PROPOSED REVISIONS

PENTHOUSE FLOOR PLAN - APPROVED & PROPOSED (REVISED)

Ⓐ - SOUTH / NORTH ROOFTOP SECTION

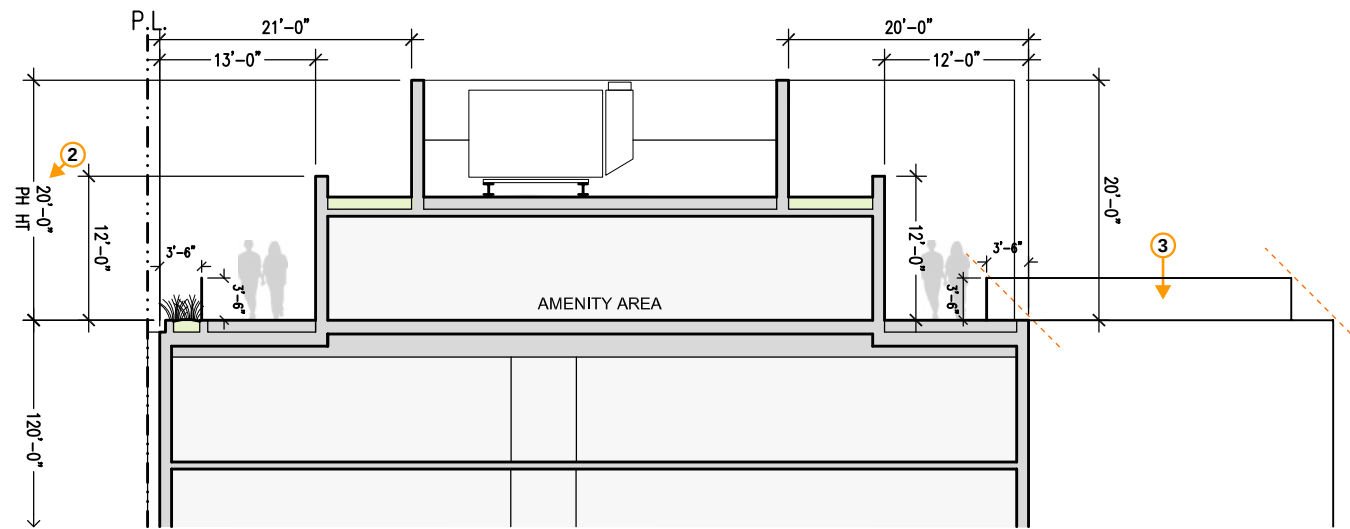
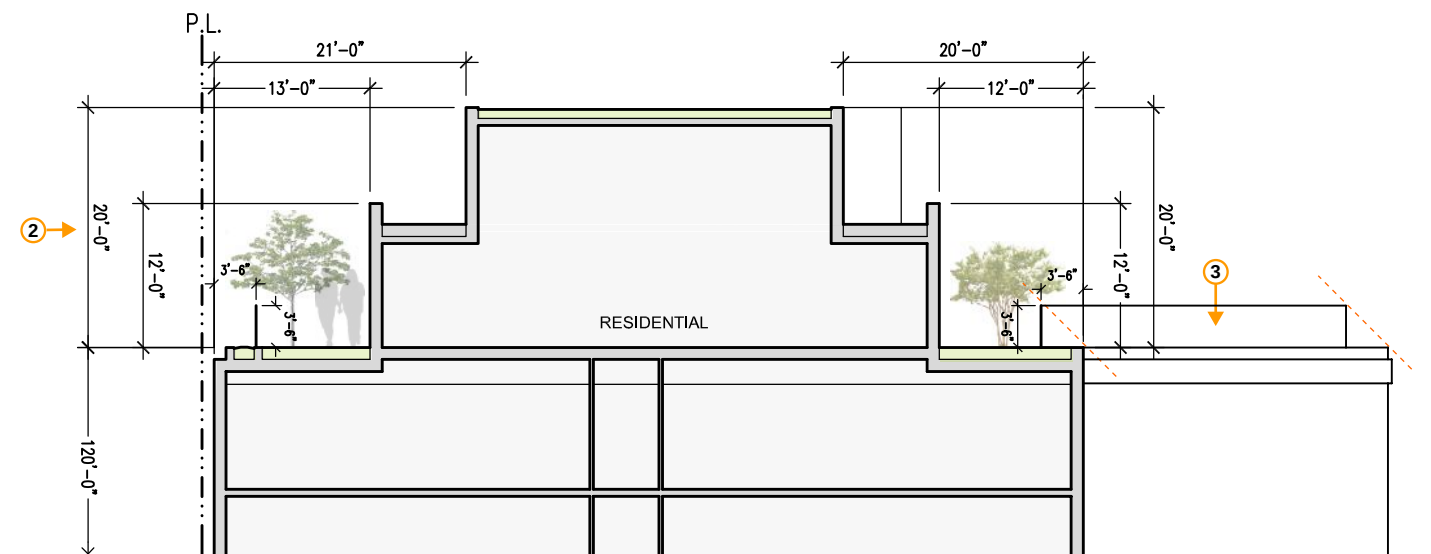
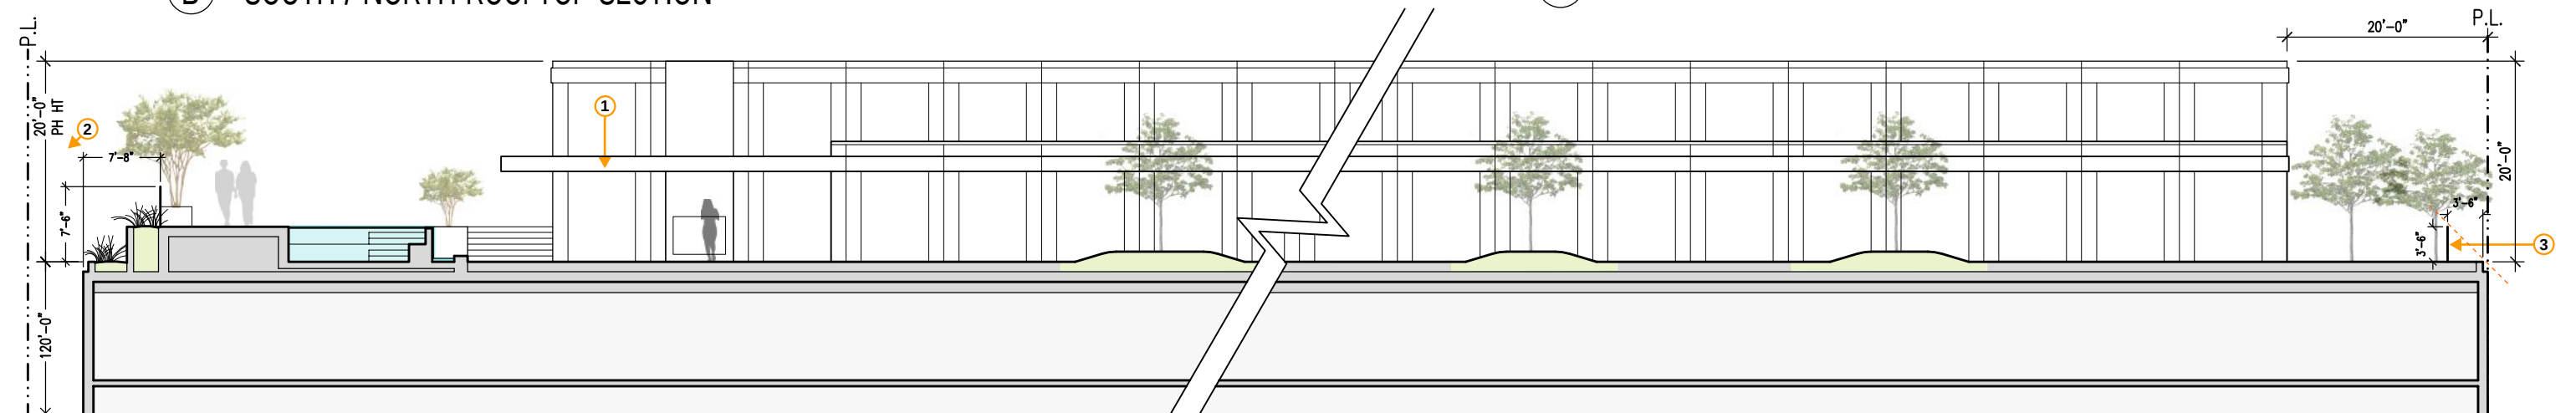
- * CHANGES TO ROOF STRUCTURE TO INCORPORATE ZC ORDER NO. 14-13
- 1. NEW TRELLIS
- 2. PENTHOUSE HEIGHT NOW 20'
- 3. REVISED RAILING (1:1 SETBACK PROVIDED)

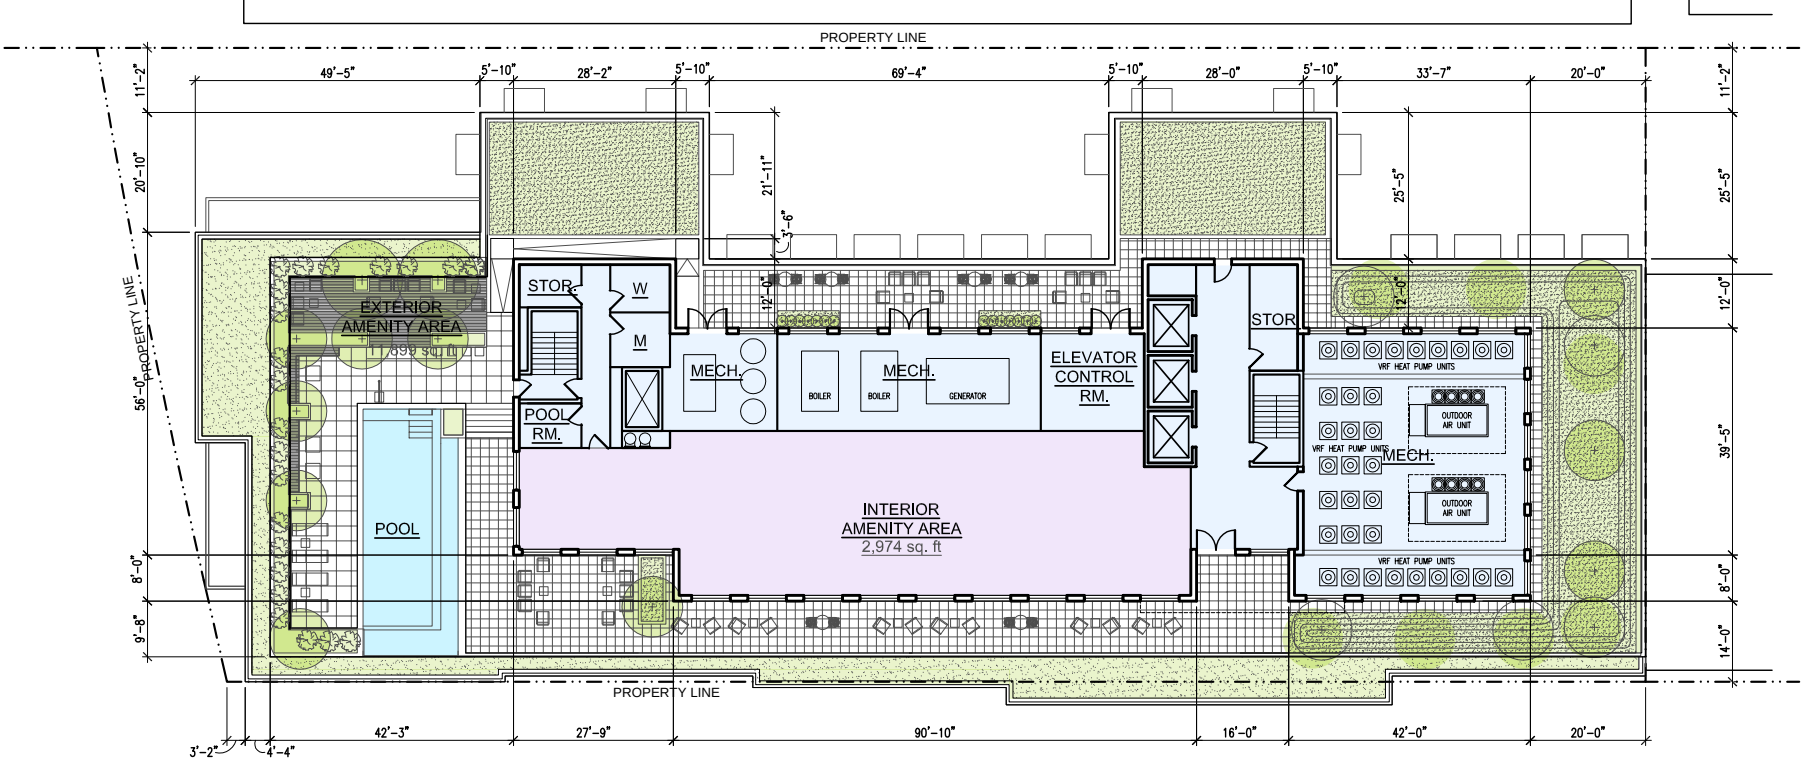
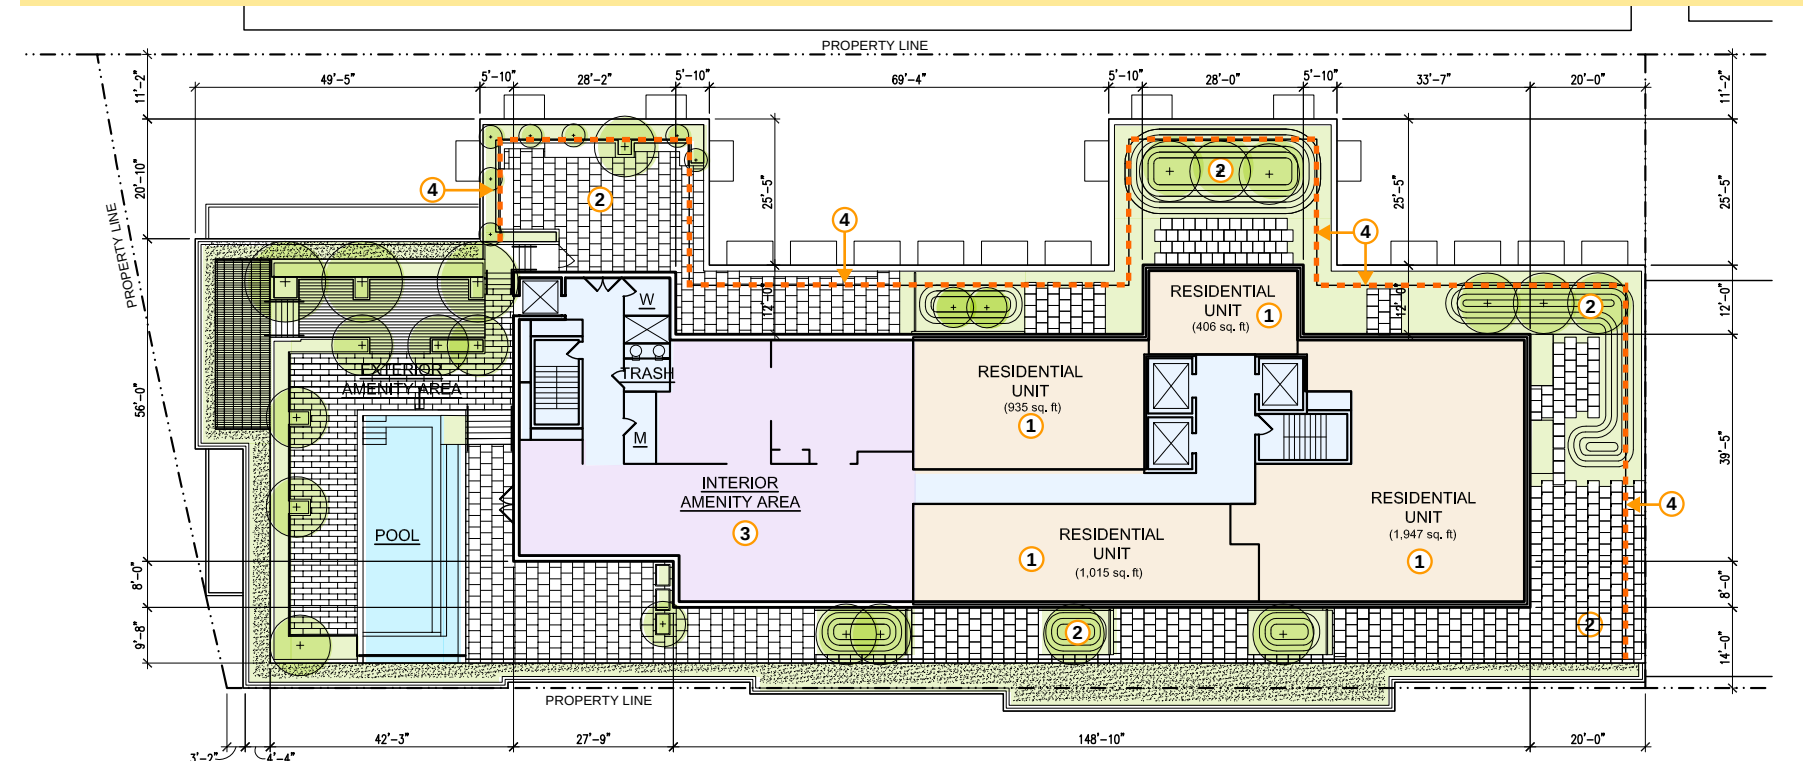
PROPOSED REVISIONS

- * CHANGES TO ROOF STRUCTURE TO INCORPORATE ZC ORDER NO. 14-13
- 1. NEW PENTHOUSE RESIDENTIAL UNIT
- 2. REVISED LANDSCAPE
- 3. NEW INTERIOR AMENITY AREA LOCATION
- 4. REVISED RAILING (1:1 SETBACK PROVIDED)
